Thank you for the opportunity to review the concept plan, for the (Takoma Junction development – SHA Tracking #19-AP-MO-008-xx) in Montgomery County, Maryland. The State Highway Administration (SHA) review is complete and we are pleased to respond.

RE: Preliminary Plan No. 120190150
Takoma Junction
AMENDED LETTER

RE: Preliminary Plan No. 120190150
Takoma Junction
REVISED LETTER

RE: Takoma Junction
Traffic Impact Study Review

Figure 9-17. Departure Sight Triangles for Intersections

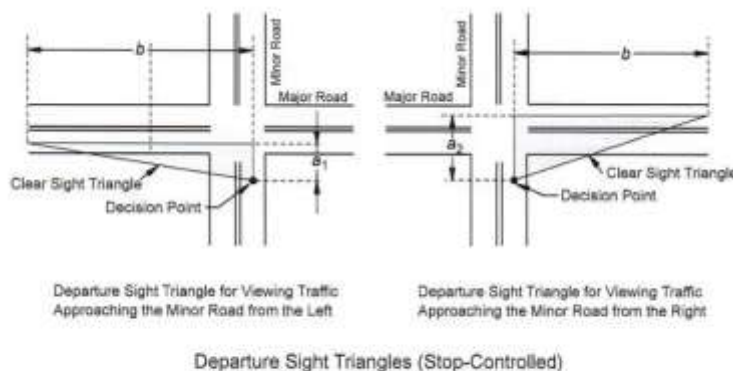
- The sight distance measurements were not conducted in accordance with professional standards of practice as specified by the American Association of State and Highway Transportation Officials (AASHTO). Please refer to the AASHTO Green Book for the appropriate methodology. The Institute of Transportation Engineers Manual of Transportation Engineering Studies and the Traffic Engineering Handbook provide additional guidance. Sight distance identified as dimension b below (for intersection sight distance), is measured as part of an intersection sight triangle with a decision point located 14.5 feet from the edge of the major road traveled way. Figure 9-17 from the AASHTO Green Book copied below illustrates.
 - Sightlines are measured along a straight line
 - Sightlines do not curve with the vehicle path
 - Sightlines do not curve around objects

Related object heights are as indicated in the Manual. Please revise accordingly.
